P 521977

**ON-SITE SEWAGE DISPOSAL SYSTEM  
HOWARD COUNTY HEALTH DEPARTMENT  
BUREAU OF ENVIRONMENTAL HEALTH**

SUBDIVISION: Kingston LOT NUMBER: 12-A

ADDRESS: 3561 Conchita Drive PROPERTY OWNER: David Simard

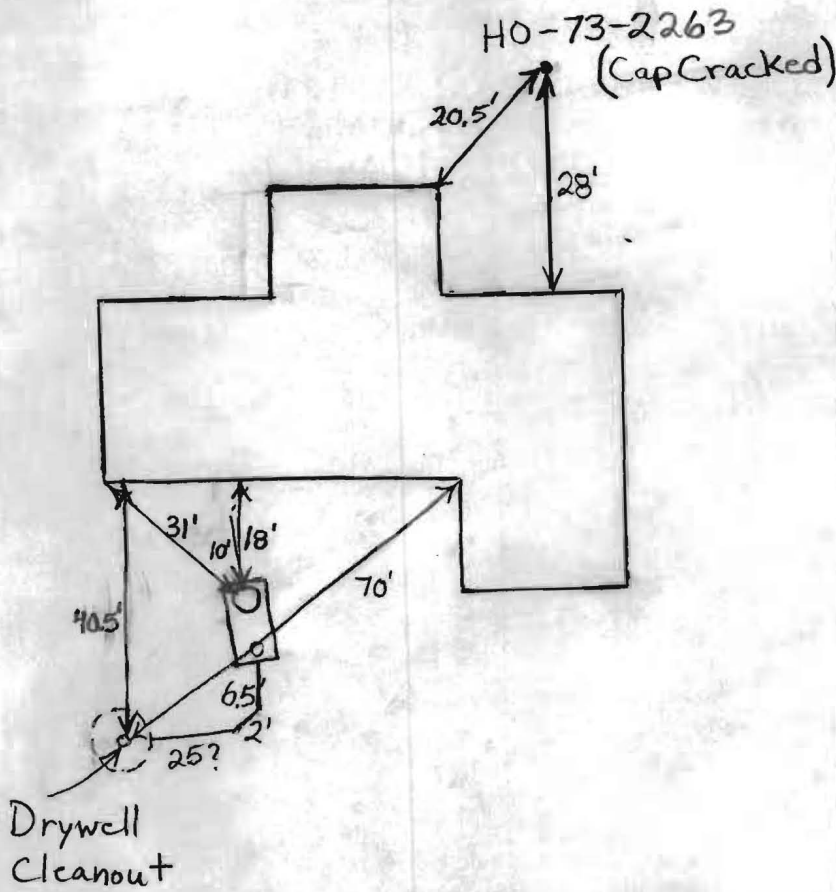
PRE-CONSTRUCTION 2/8/05 Replacement septic tank will be deep wherever it is installed. Traffic bearing lid is required.

INSTALLATION Tank should still be located where it will have no more than 5' of cover over it. (BB) 2/9/05 Tank set too deep. Told Fryock to send us guarantee from tank company that said the tank would be O.K. at 6.5' depth. (BB) 2/10/05 Tank company said that the tank would probably be O.K. at 6.5' but would not offer any guarantee. Fryock's said they would guarantee that tank would be able to withstand weight of dirt. However the Health Department

makes no guarantee on tank. Permit to be filed away without Health Department approval. (BB)
